Merton Council

Planning Applications Committee

7 November 2013

Modifications Sheet.

30 Arthur Road
Amended Tree Protection Plan

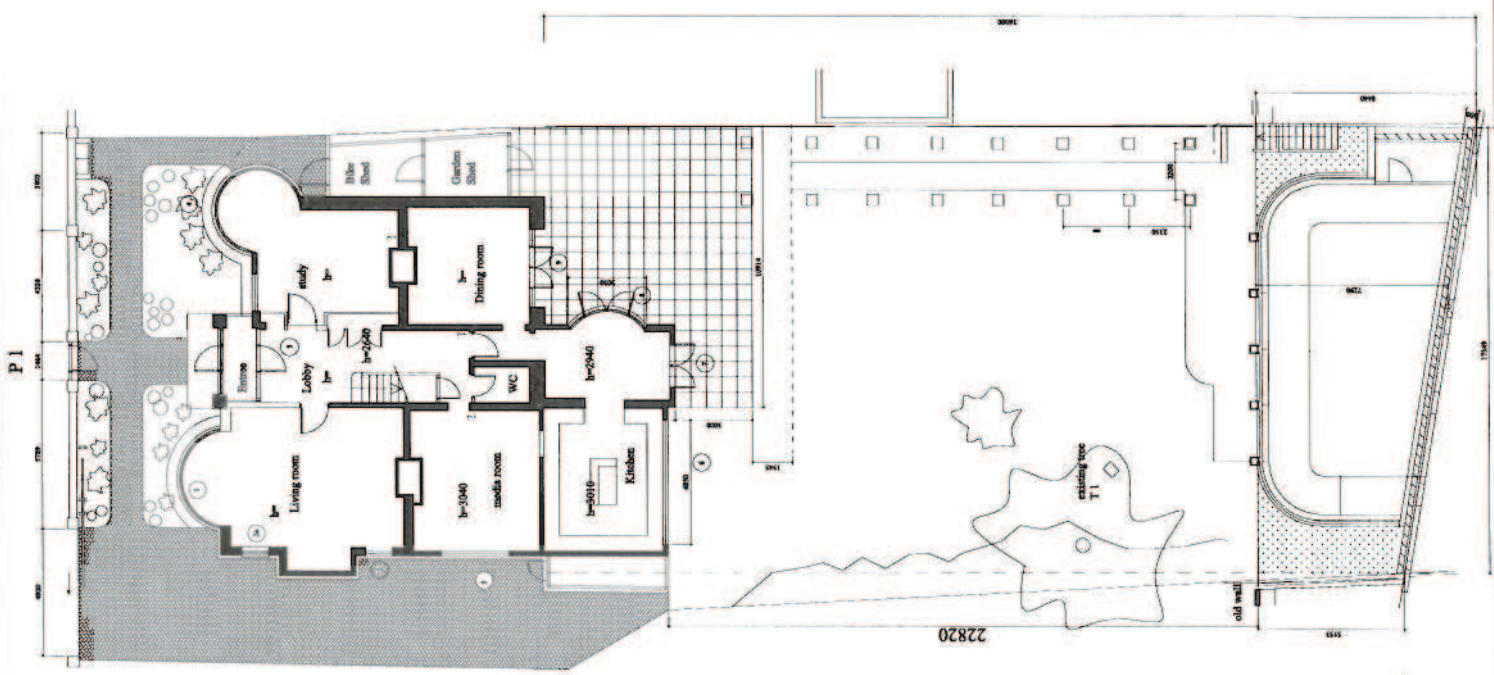
Amended tree protection plan.

Simply Architects		Date:
Tel: +31 6 24077096 Email: info@simply-architects.com www.simply-architects.com		Project:
Simply Architects / Chico		Subject:
Marryat Road		As proposed Plans
Proposed Site Plan		Drawing:
Scale: 1:200		Sheet: 01
Project number:		Drawing Number: P 010

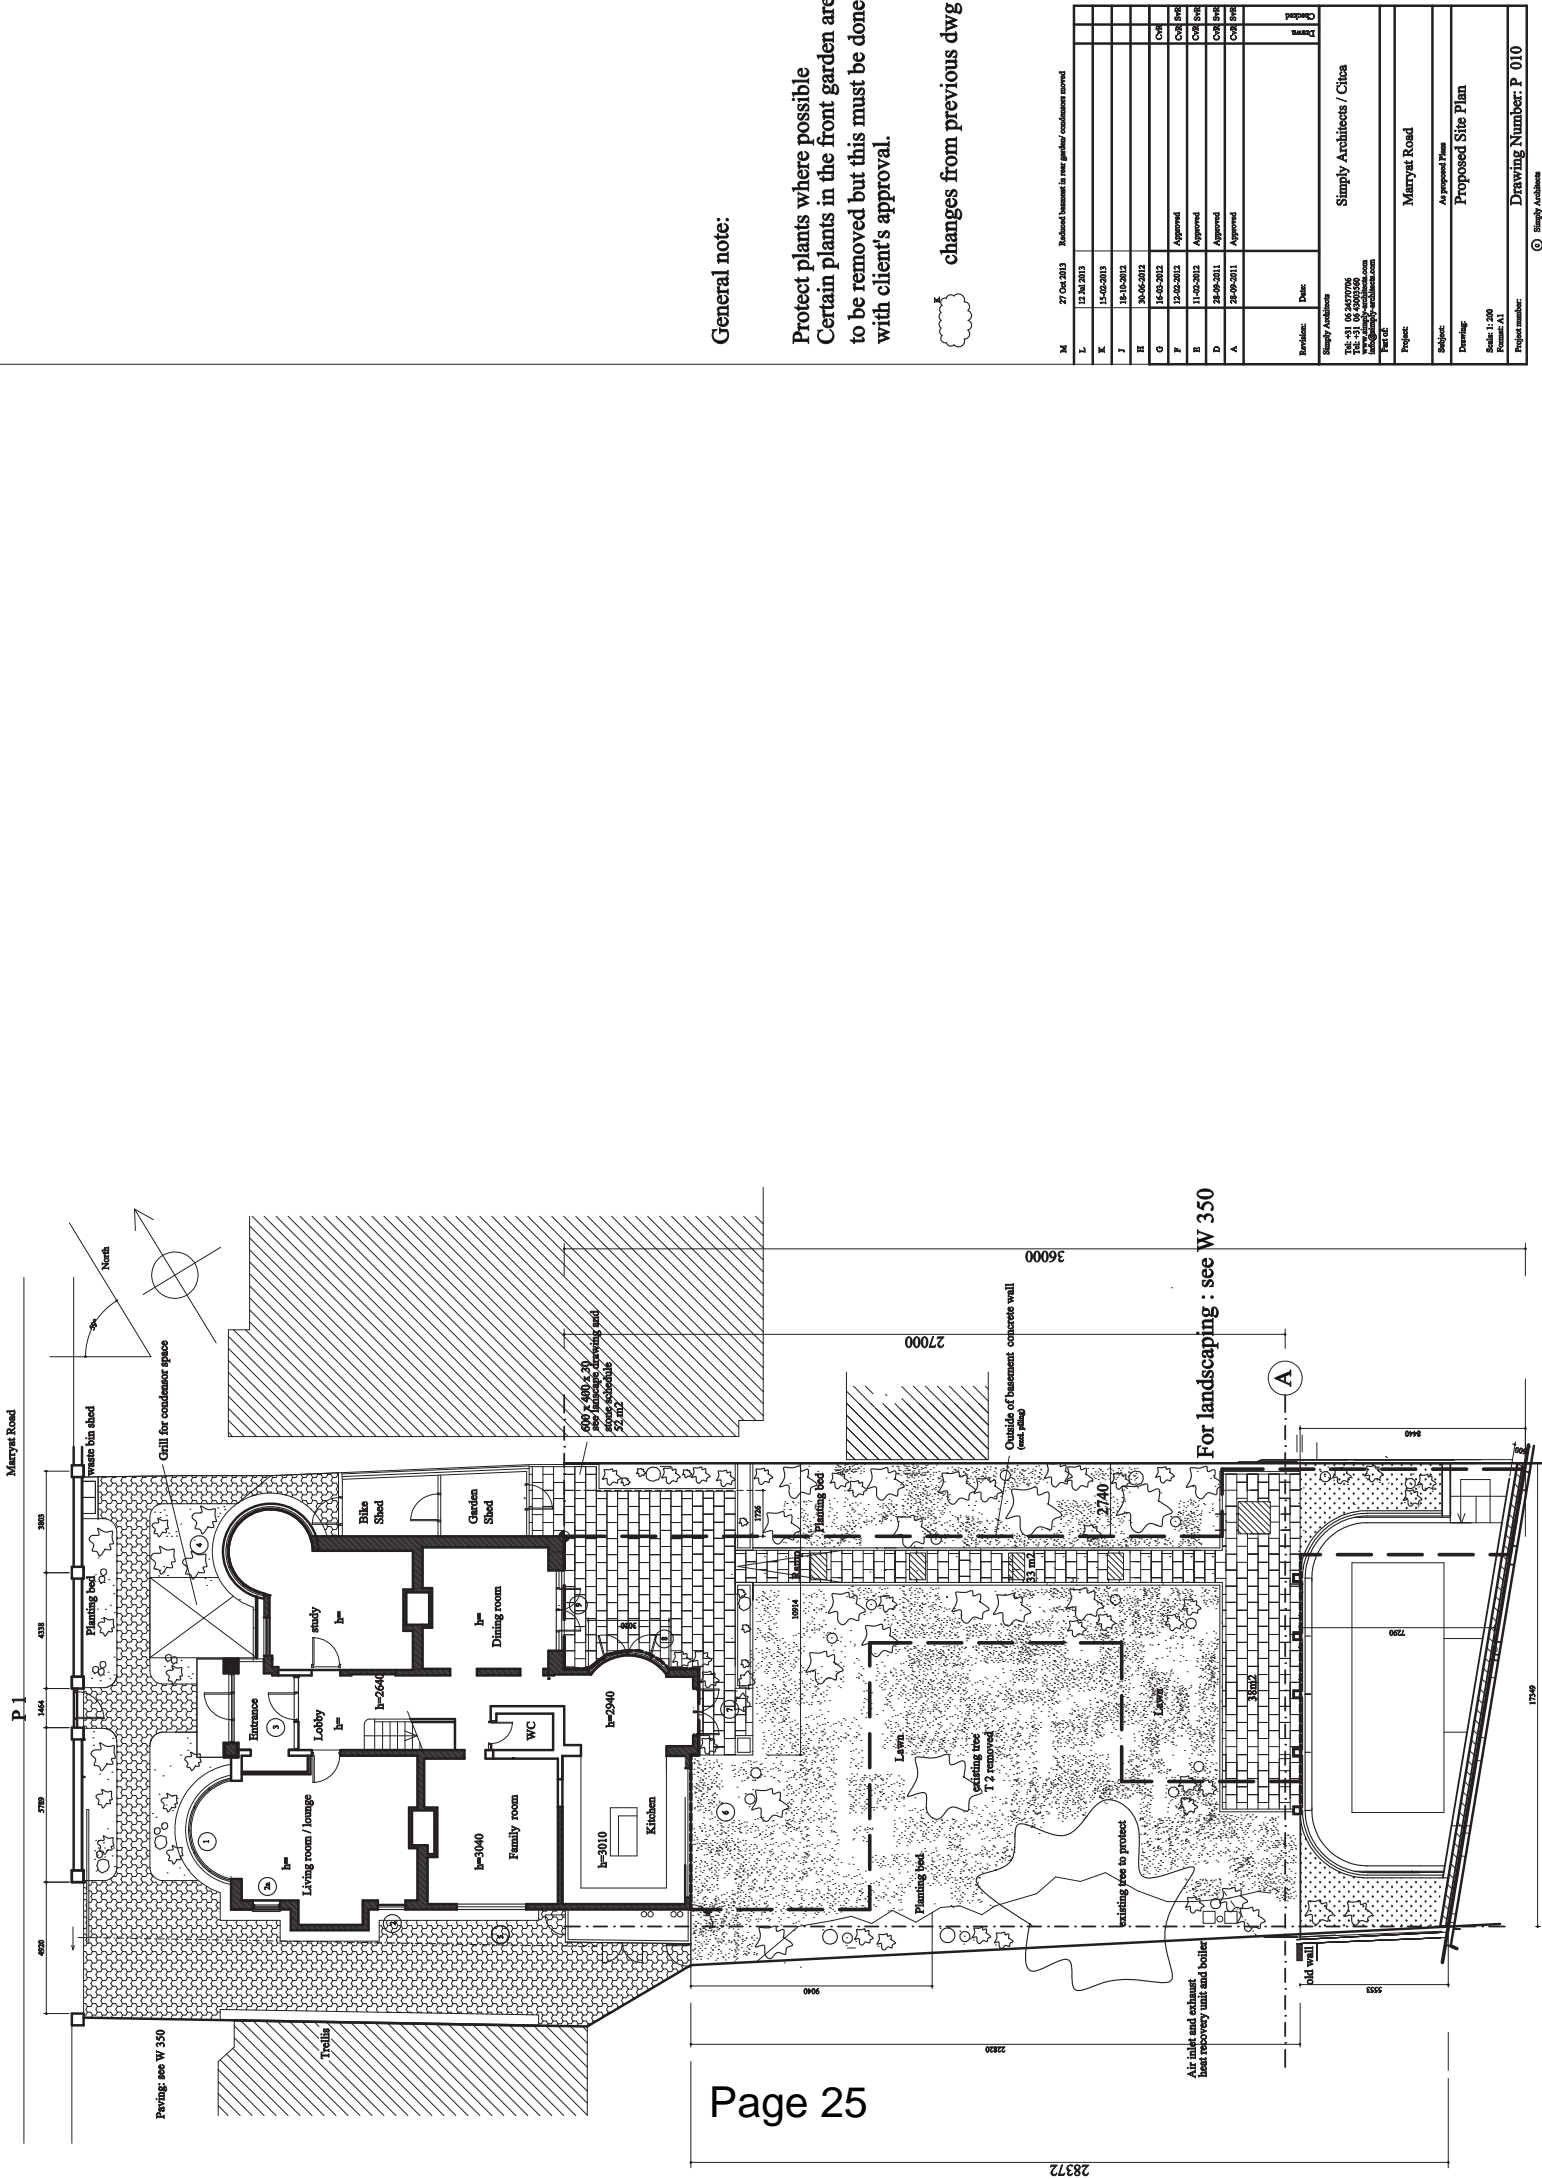
P010 amended by drawing number P 010 Rev M.

Amendments include existing path moved away from boundary with 16 Marryat Road and underground condenser moved to front of house. Extent of basement indicated by dotted line.
